PCI-SIG ENGINEERING CHANGE REQUEST

TITLE:	Port & Cable Aggregation ECR
DATE:	April 13, 2018
AFFECTED DOCUMENT:	OCuLink 1.0
SPONSOR:	Alex Haser; Molex

Figure 3-2. Port Aggregation for x4 Fixed Host Board-side Connectors with Uniform Orientation

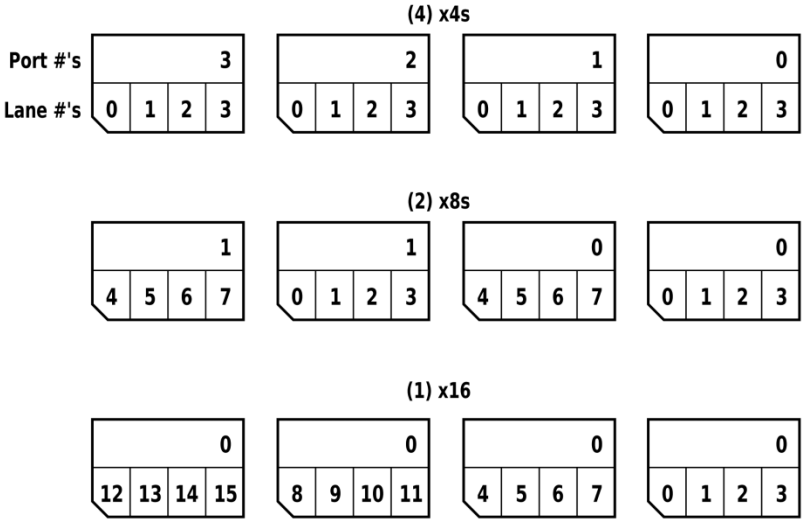
The basic Lane numbering and pin numbering for Fixed Host Board-side connectors is shown in Figure 3-1 for reference. OCuLink Ports (x4, x8, and x16) must be aggregated as shown in Figure 3-2 and Figure 3-3 and must meet the marking/labeling requirements listed in Section 8.
